RE: DA 2022 1425; 132A Queens Parade East Newport 2106

WRITTEN SUBMISSION: LETTER OF OBJECTION
SUBMISSION: TULLOCH

**RE: ADDITIONAL INFORMATION RESPONSE
132a QUEENS PARADE EAST, NEWPORT (DA2022/1425)**

Figure 1: East elevation

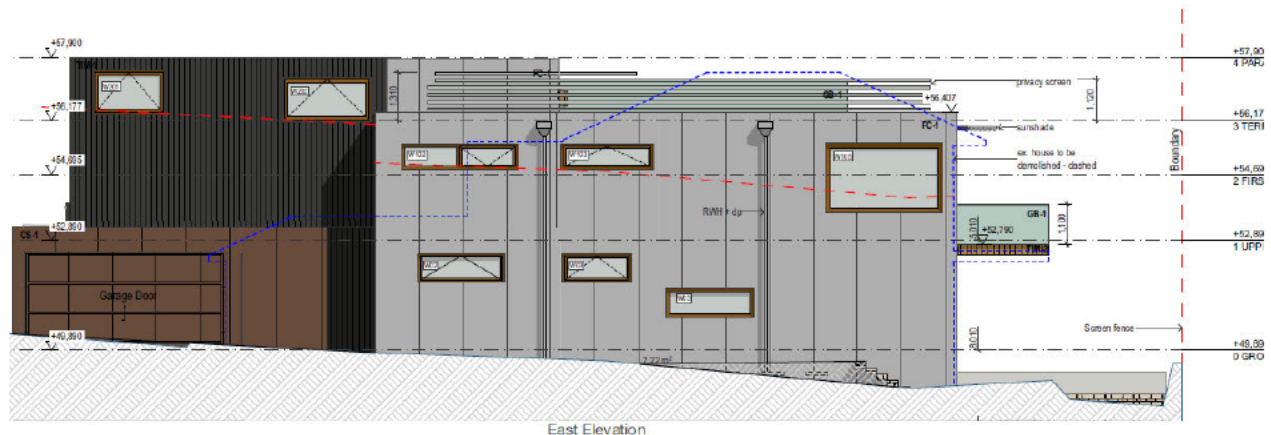
The eastern elevation does breach further down the dwelling towards the rear. We note that the existing dwelling is sited towards the eastern boundary and the outline of the existing dwelling is shown below:

The blue hatch shows the existing dwelling to be demolished (footings retained) and the red hatch line shows the building envelope control. It is considered that the bulk and scale relationship of the proposed dwelling when viewed from No. 134 would not be dissimilar to the existing relationship in terms of its visual impact. The retention of the existing footings does contribute to the extent of the breaches also.
